Technical Service Bulletin (TSB)

Adaptive Cruise Control (ACC) Radar Vertical Misalignment

REFERENCE:	TSB: 08-006-26 GROUP: 08 - Electrical	Date:	January 9, 2026	REVISION:	08-200-25
VEHICLES AFFECTED:	2022 - 2025 (MP) Jeep Compass This bulletin applies to vehicles equipped with 2.0L I4 DOHC DI Turbo Engine w/ ESS (Sales Code EC1) with Trailhawk Badge (Sales Code M1E) and **Full Speed FWD Collision Warn Plus (Sales Code LSU)**.			MARKET APPLICABILITY: ☒ NA☐ MEA ☐ SA☐ IAP ☐ EE☐ CH NOTE: This bulletin applies to the North America market.	
CUSTOMER SYMPTOM:	Customers must experience a Malfunction Indicator Lamp (MIL) illumination and the vehicle must exhibit/set the following Diagnostic Trouble Code (DTC): - C14A4-00 - Sensor Adjustment Required. Customers may also experience the following: "ACC/FCW Unavailable, Service Required" message in the Instrument Panel Cluster (IPC). NOTE: This message can appear on extreme windy conditions at speeds of 97 kph (60 mph) to 113 kph (70 mph).

Fig. 1
ACC Module Bracket Assembly

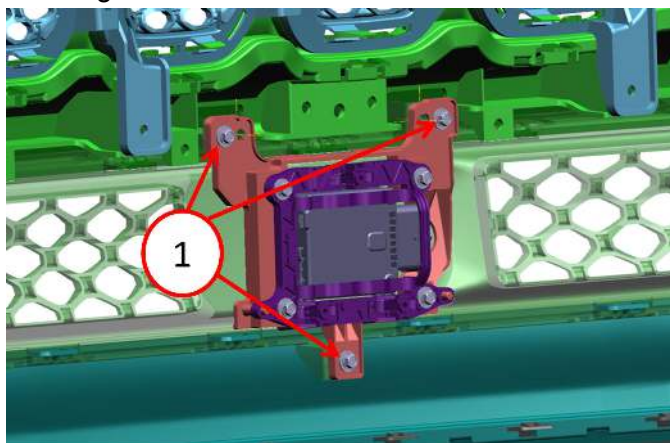
1. **Remove the front fascia. Refer to the detailed service procedures available in DealerCONNECT/ Service Library under: Service Info>13 - Frame and Bumpers / Bumpers / Fascia, Front / Removal.
2. Disconnect the electrical connector from the ACC module radar.
3. Remove the three fasteners holding the ACC module bracket to the front fascia [Fig. 1](#).

5. Install the third ACC module bracket fastener to the front fascia.
6. Tighten all fasteners [Fig. 1](#) securely.
7. Connect the electrical connector to the ACC module radar.
8. Install the front fascia. Refer to the detailed service procedures available in DealerCONNECT/ Service Library under: Service Info>13 - Frame and Bumpers / Bumpers / Fascia, Front / Installation.**
9. Perform an ACC DASM Calibration. Refer to the detailed service procedures available in DealerCONNECT/Service Library under: Service Info> 08 - Electrical / 8E - Electronic Control Modules / Module, Adaptive Cruise Control (ACC) / Module Programming.
10. Clear DTCs.

Fig. 2
ACC Module Bracket Fascia Retainers

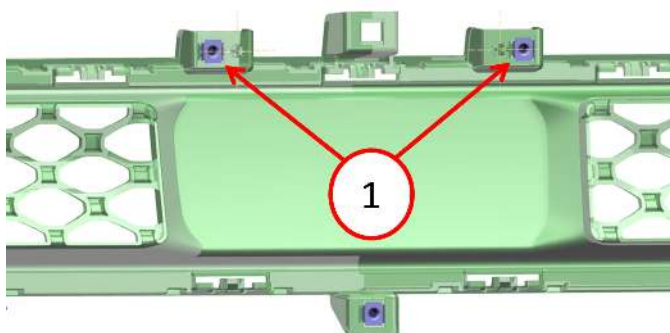
4. Install two flat washers while installing the top two ACC module bracket retainers on the front fascia [Fig. 2](#).

1 - Install Two Flat Washers To The Two Fascia Bracket Retainers

****This bulletin involves installing two washers to the Adaptive Cruise Control (ACC) radar bracket behind the front fascia.****
